DEVELOPMENT REVIEW BOARD REPORT

Meeting Date: November 20, 2025
General Plan Element: *Character and Design*
General Plan Goal: *Foster quality design that enhances Scottsdale as a unique southwestern desert community.*

**The Arden Scottsdale
32-DR-2024** | Request for approval of a site plan, landscape plan, and building elevations for a new 23-unit multi-family development in 5 three-story buildings on a +/- 1-acre site.

SITE PLAN FOR "THE ARDEN SCOTTSDALE" PROJECT

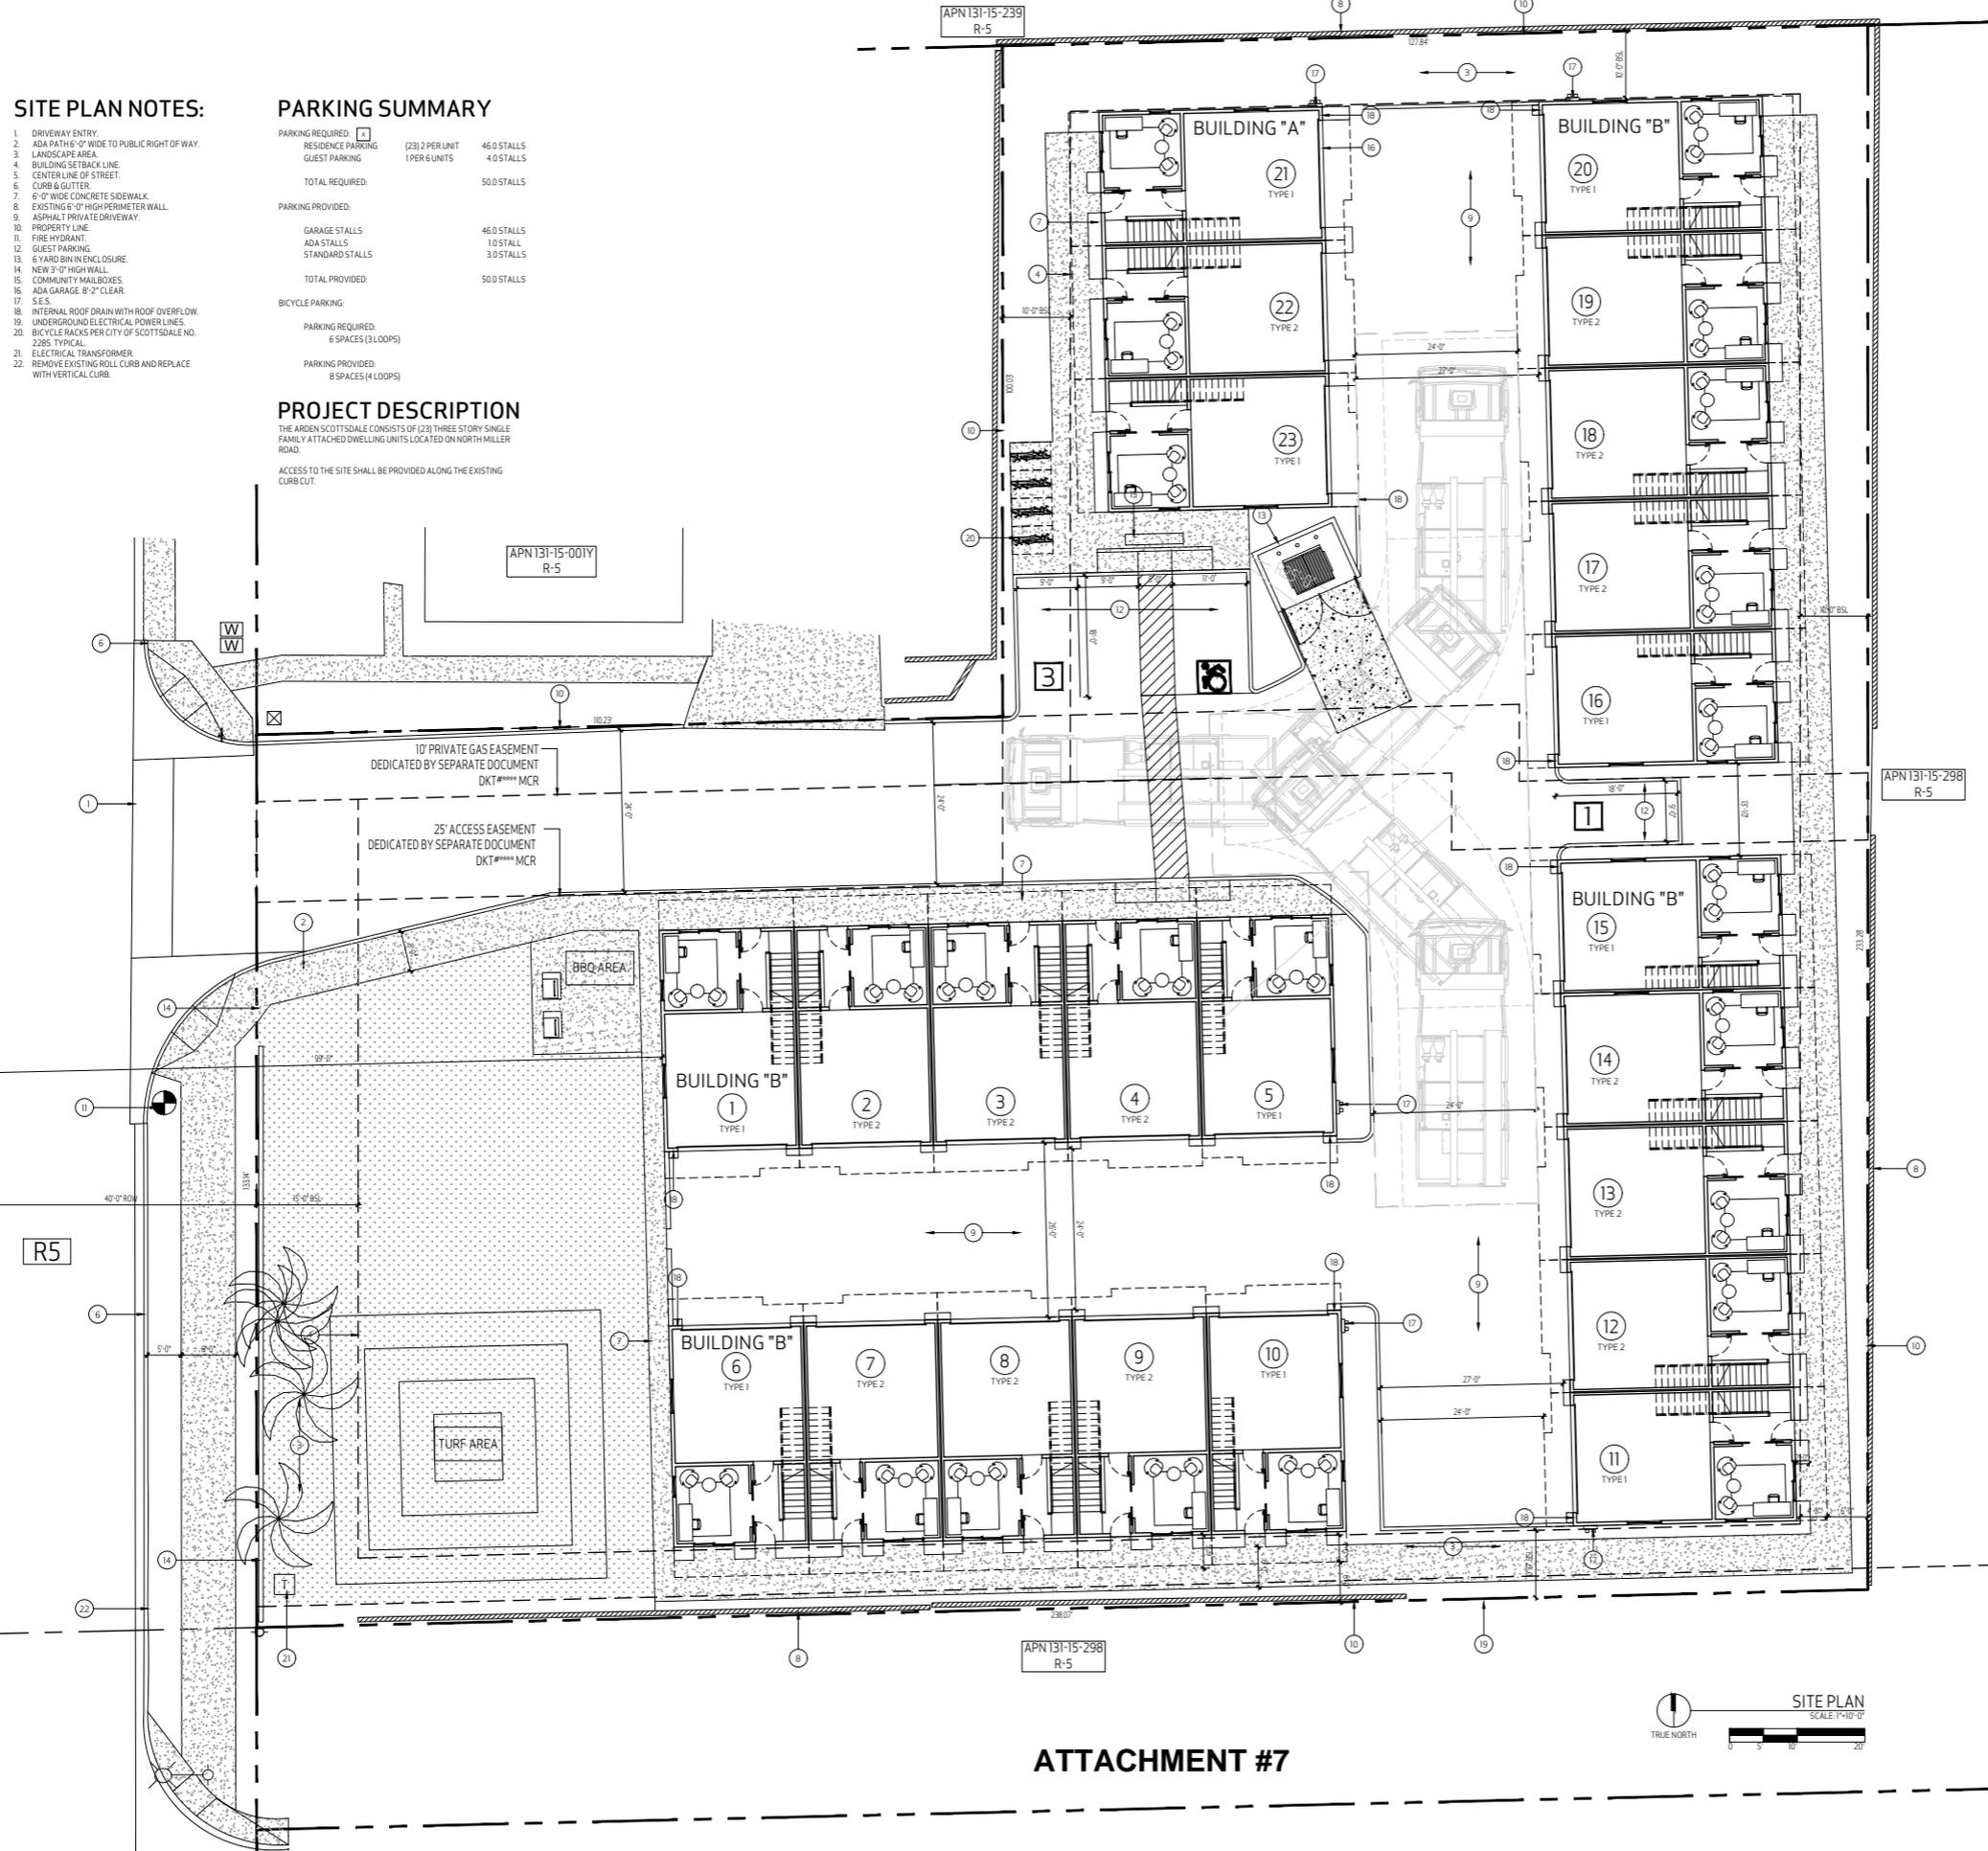
I'm wondering if any consideration was given to orientation of the buildings to accommodate more open space around the buildings, or protection of views to the residents to the east? A reorientation of the units might provide room for landscape areas between unit drives and adjacent to patios, to provide a cooler environment with more open space. The main drive could be lined by patio trees in planter strips between drives. This configuration provides a more varied street front and variation in building massing.

One concern I have is the distance between the east side apartments to the property line on the east where there are existing condominiums (owner occupied product). At the narrowest point it appears the Building B will be 10' from the property line and at the widest 19' from the property line, inclusive of a 3' wide sidewalk, leaving limited room for tree growth between the perimeter wall and the new buildings. I'm wondering if Ghost Gum might be more appropriate as a fast growing screen tree on the east side. This would provide more biodiversity and tie into the existing landscape character of the area with existing eucalyptus trees. I would suggest changing the pistache to ghost gum on the east side. As a separate note, looking at an aerial, Scottsdale Casitas to the north is missing landscape in their landscape islands and south side perimeter. Can you please mention this to code enforcement? Existing projects need to keep their properties up to maintain the appearance.

The site plan references an existing 6' high perimeter wall, this is not the case on the south side of the site, where new residences are being built adjacent to a commercial site. I would recommend that they

provide a 6' CMU wall with 2' of steel picket on top to secure the new apartments from access from the parking area to the south.

The units on the south of the site have no landscape at all separating them from the commercial uses to the south. This also provides no shade on the southern side of these buildings. Why is there no landscape shown adjacent to the patios on these units on the main drive into the site? there should be landscape along the drive in front of these units. There should also be trees on the western side of the units to shade the building.

LANDSCAPE/HARDSCAPE PLAN

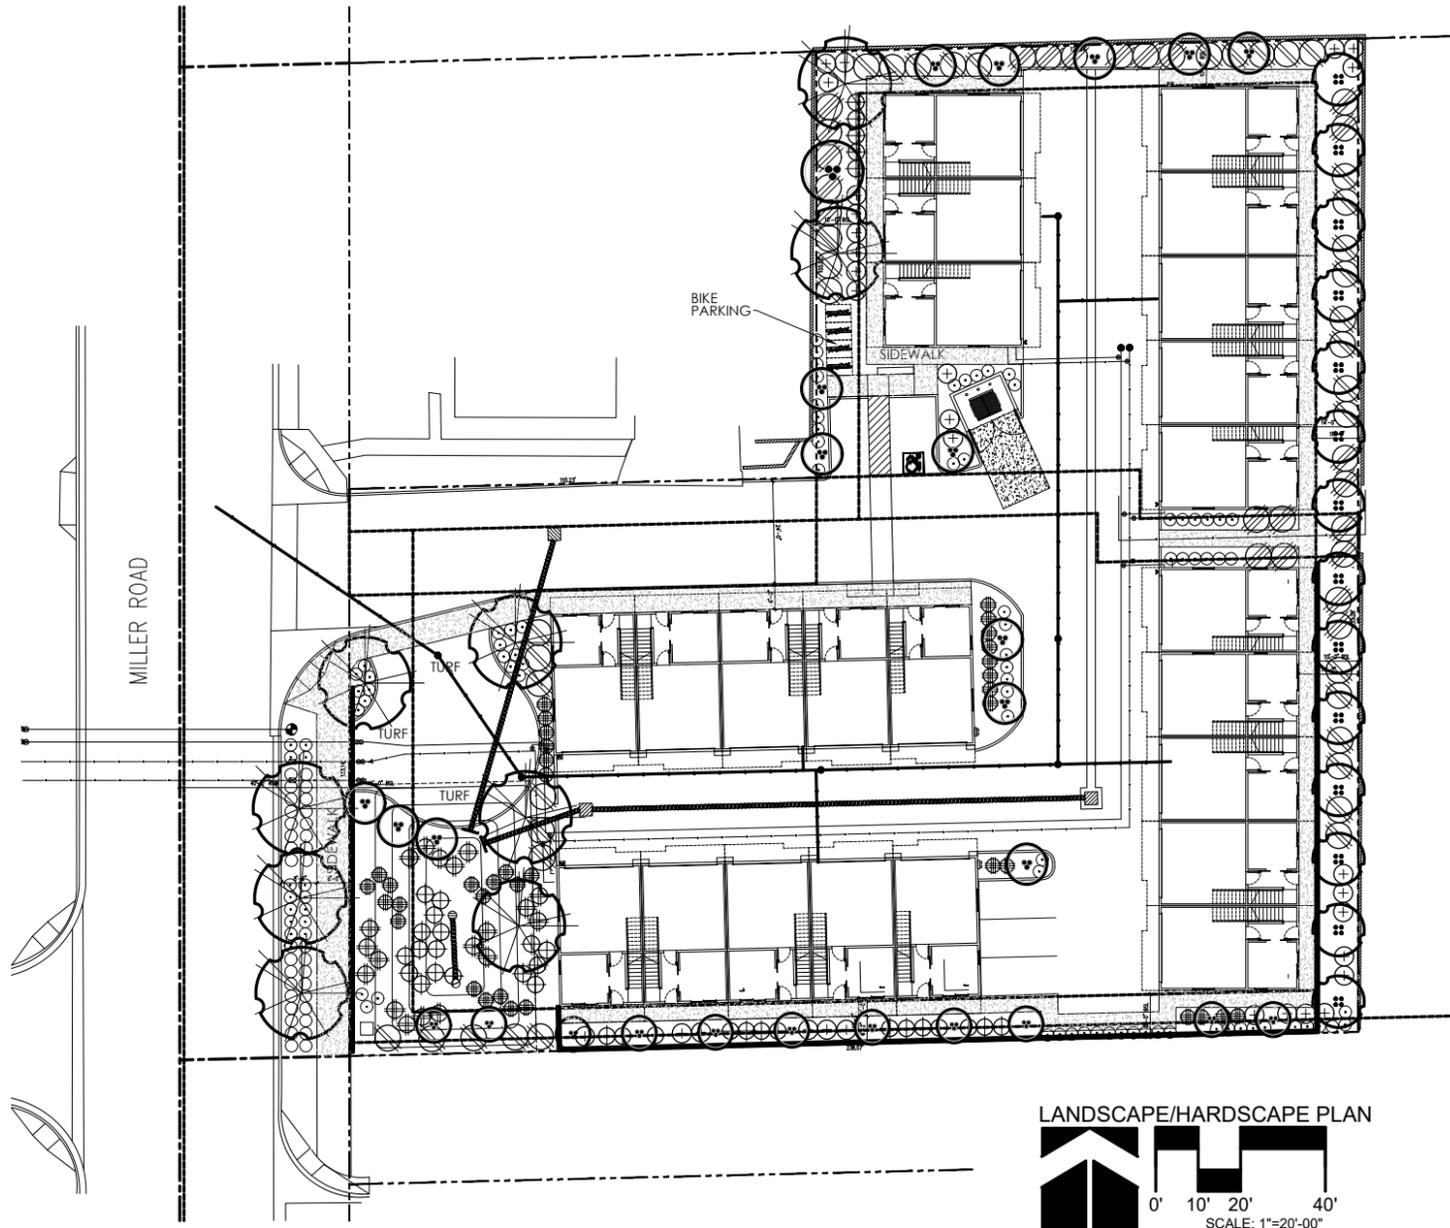
In addition, the proposed perimeter trees, *Caesalpinia cacalaco* and *Pistacia X* only grow to a height of 10 and 20 feet respectively under ideal weather conditions in this climate and after decades. It will take many years of perfect care for the desired height of the trees to provide our development minimal privacy. A larger setback and broken up buildings would be more effective at doing so.

The Arden

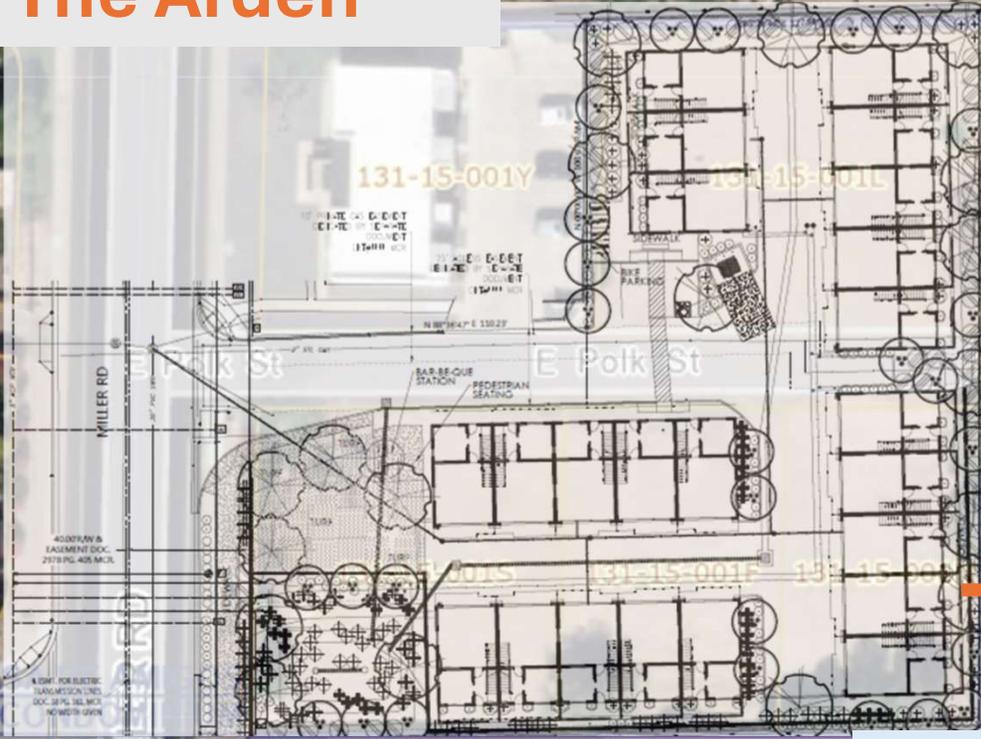
21 ft setback at closest point

Direct view from balconies at the Arden into bedroom windows at Casa de Amigos at less than 21 ft distance

The Arden (R-5)	Casa de Amigos (R-5)
3 stories	2 stories
No stepbacks, instead, a pop out at 2 nd and 3 rd stories	No stepbacks

These will be two, 100 ft long, 33 ft high walls of contiguous balconies looking into our bedroom windows. In my case, the balconies will be 21 ft away from my bedroom windows
